# METROPOLITAN GOVERNMENT OF NASHVILLE AND DAVIDSON COUNTY

Metropolitan Historic Zoning Commission  
Sunnyside in Sevier Park  
3000 Granny White Pike  
Nashville, Tennessee 37204  
Telephone: (615) 862-7970  
Fax: (615) 862-7974

## STAFF RECOMMENDATION 2300 10<sup>th</sup> Avenue South December 18, 2019

**Application:** New Construction—Addition  
**District:** Waverly-Belmont Neighborhood Conservation Zoning Overlay  
**Council District:** 17  
**Base Zoning:** R8  
**Map and Parcel Number:** 10513037500  
**Applicant:** Will Jenner of Axis Creative, LLC  
**Project Lead:** Sean Alexander, sean.alexander@nashville.gov

SITE PLAN

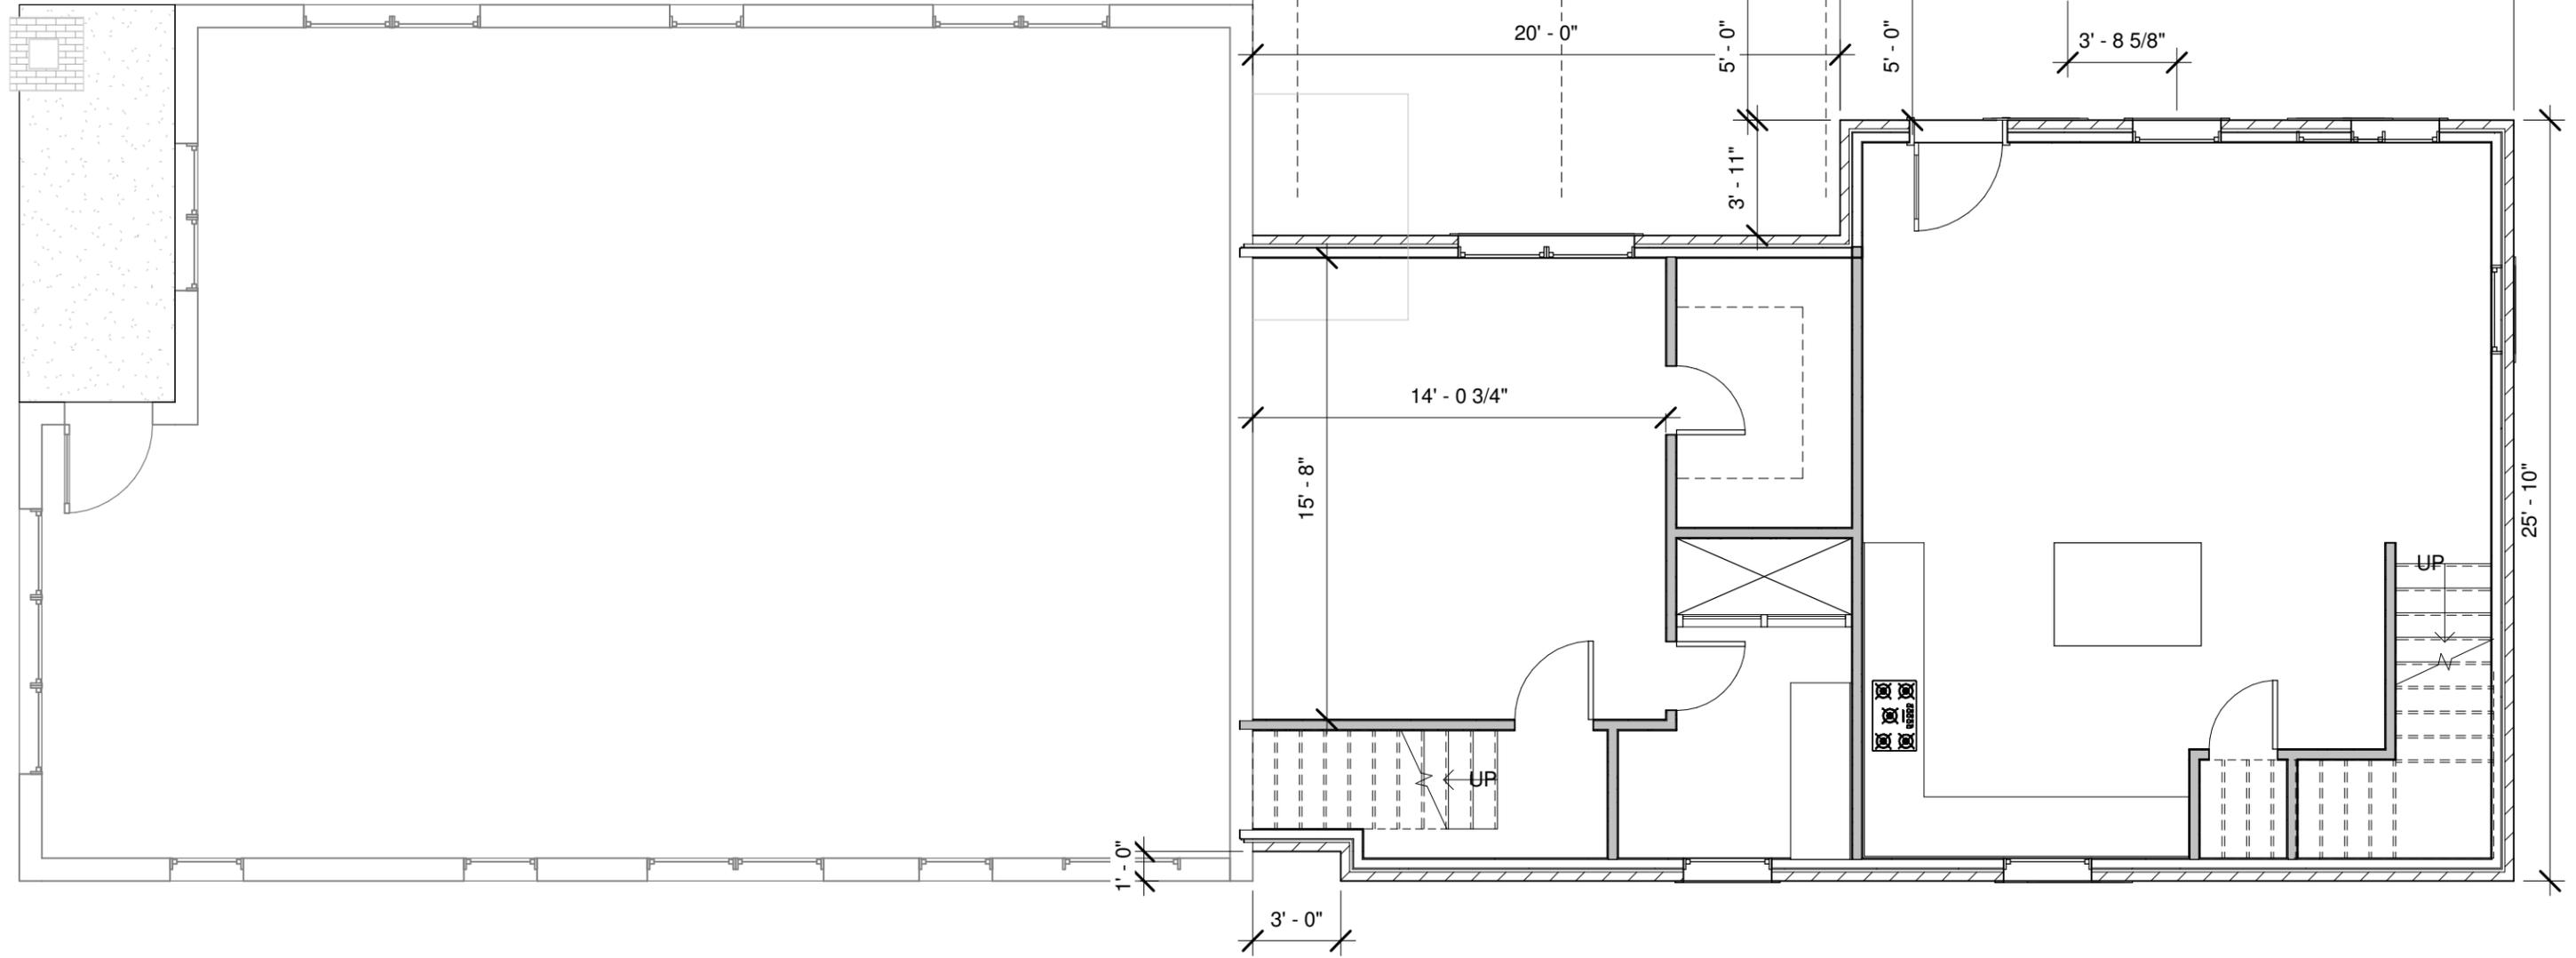
Setback & Rhythm of Spacing: The addition will have side setbacks of thirteen feet (13') on the left facing Waldkirch Avenue, eight feet (8') on the right, and twenty-three feet (23') on the rear. These setbacks will not disrupt the rhythm of spacing between houses, in part because the lot is on a corner but also because the addition is narrower than the historic house.

Appurtenances & Utilities: The lot currently has two curb-cuts from Waldkirch Avenue. The curb cut at the rear of the lot is on the subject property, but it functions and looks like an alley serving other properties on 10<sup>th</sup> Avenue South, Waldkirch, and Caruthers Avenue. Although it is not an alley proper, other users may be entitled to continued use via a prescriptive easement.

alley access to one street-accessed driveway per lot and limit driveway width to twelve feet (12'). Similarly, the Public Works typically does not allow multiple curb-cuts to be so close to one another on one frontage of a single lot. To this end, staff recommends having only one driveway entering the lot directly from Waldkirch Avenue, and retaining the shared drive at the rear with parking for the second unit accessing it from the rear.

The location of the HVAC and other utilities was not noted in the plans. Staff asks that the HVAC be located on the rear façade, or on a side façade beyond the midpoint of the house.

Staff finds that, with the condition that the lot shall have only one driveway entering the lot directly from Waldkirch Avenue, and retaining the shared drive at the rear with parking for the second unit accessing it from the rear, and that the HVAC shall be located on the rear façade or beyond the midpoint of the house, the project will meet section III.H.6. and III.I. of the design guidelines.

1. The window and door selections, metal roof color, and porch column material shall be approved prior to construction; and
2. The side and rear dormers shall be revised to not be wall dormers; and
3. The lot shall have only one driveway entering the lot directly from Waldkirch Avenue, and retaining the shared drive with parking for the second unit entering the lot from the rear; and
4. The HVAC units and utilities shall be located on the rear façade or beyond the midpoint of the house.

LEFT ELEVATION

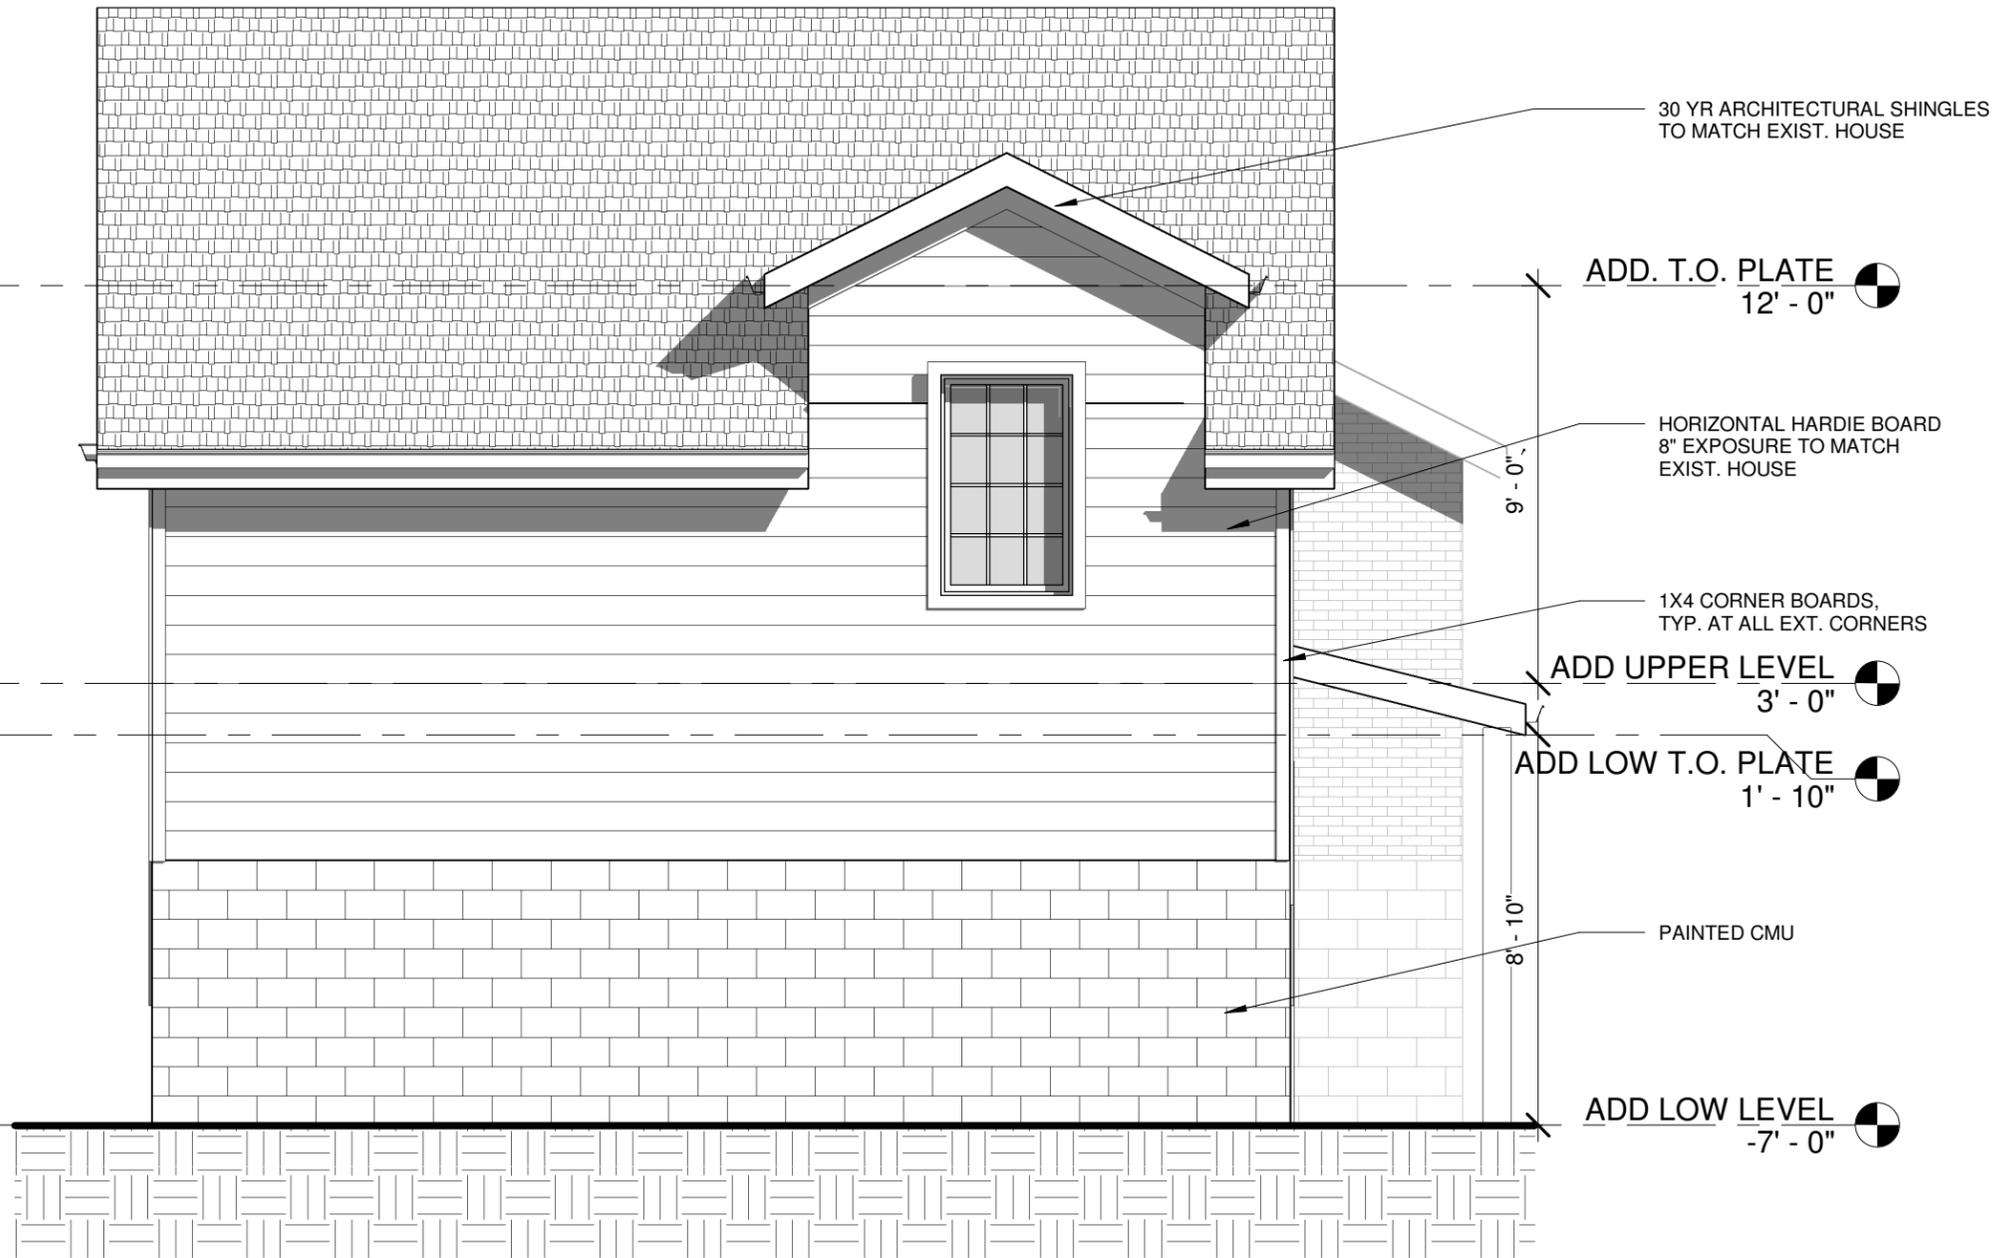
The addition will have wall dormers, dormers which are not stepped back from the primary wall below, on the left side of the addition and on the rear. Wall dormers are typically not appropriate, and although these dormers will be minimal in scale, staff finds that revising them to a gablet or comparable form would be appropriate.

To accommodate the second dwelling, the addition will have an doorway on the left side facing Waldkirch Avenue, located in the lower level that will be acquired due to the drop in grade at the rear. The side entrance will have a seven foot (7') wide by five foot (5') deep covered stoop. The minimal size of the entry, along with its location in the lower level, will help it to read as a secondary entrance.

Proportion and Rhythm of Openings: The addition will have double-hung windows, in single units and in pairs, regularly spaced on both levels on the left side.

With a condition that the addition does not have wall dormers, staff finds the roofs of the proposed addition will be compatible with the historic house, and that the project meets sections III.E and IV.C of the design guidelines.
